Access Compliance Report

Public Rights-of-Way

(Curb Ramps)

Intersection ID: 47454	Main Street: WOOD_DUCK_CROSSING_DR	Cross Street: WINGED_TEAL_RD	Location: SE
ADA ID: 179321D9DDB4	Ramp Type: BlendTrans1	Initial Pass/Fail: Fail	Overall Compliance: No
Severity Score: 8.75			
Codes/Mitigation Info/Possible Solution		Field Measurements/Component Compliance

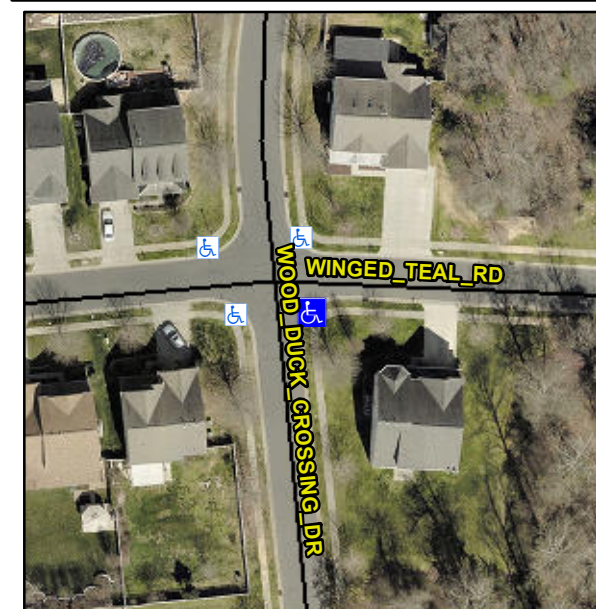
Not Found, R304.5.1

Compliance	Description	Data	Compliance	Description	Data
N/A	Ramp Length (in)	50.5	Yes	BlendTrans Slope (%)	4.0
No	Ramp Width (in)	46.5	Yes	BlendTrans XSlope (%)	0.9
N/A	Flare Type LT	N/A	N/A	Flare Type RT	N/A
N/A	Flare Slope LT (%)	N/A	N/A	Flare Slope RT (%)	N/A
N/A	Flare Traversable LT?	N/A	N/A	Flare Traversable RT?	N/A
N/A	Landing Length (in)	N/A	N/A	DWS Provided?	N/A
N/A	Landing Width (in)	N/A	N/A	DWS Contrast?	N/A
N/A	Landing Slope (%)	N/A	N/A	DWS Length (in)	N/A
N/A	Landing X Slope (%)	N/A	N/A	DWS Full Width?	N/A
N/A	Landing Curb? (Y/N)	N/A	N/A	DWS Offset (in)	N/A
N/A	Shared Landing?	N/A			
N/A	Gutter Ponding?	N/A	N/A	Gutter Slope (%)	N/A
N/A	Gutter Lip Ht (in)	N/A	N/A	Gutter X Slope (%)	N/A
N/A	Painted X Walk1?	No	N/A	Painted X Walk2?	No
	X Walk 1 Direction	To N		X Walk 2 Direction	To W
	X Walk 1 Width (in)	N/A		X Walk 2 Width (in)	N/A
	X Walk 1 Slope (%)	4.7		X Walk 2 Slope (%)	4.9
	X Walk 1 X Slope (%)	0.9		X Walk 2 X Slope (%)	2.6

N/A	Ramp inside XWalk1?	N/A	N/A	Ramp inside XWalk2?	N/A
	Road Slope (%)	0.1		Clear Space?	N/A
	Road X Slope (%)	9.0	N/A	Clear Space to XWalk (in)	N/A
N/A	Any Obstructions?	N/A	N/A	Storm Grate/Utility Hazard?	N/A
	Obstruction Type			Storm Grate/Utility Type	
		N/A			N/A
		Yes		Surface Condition? (G/P)	Good
		No		Curb Slope (%)	10.5

Remove & Replace Curb Ramp With Two New Directional Ramps or Equivalent.
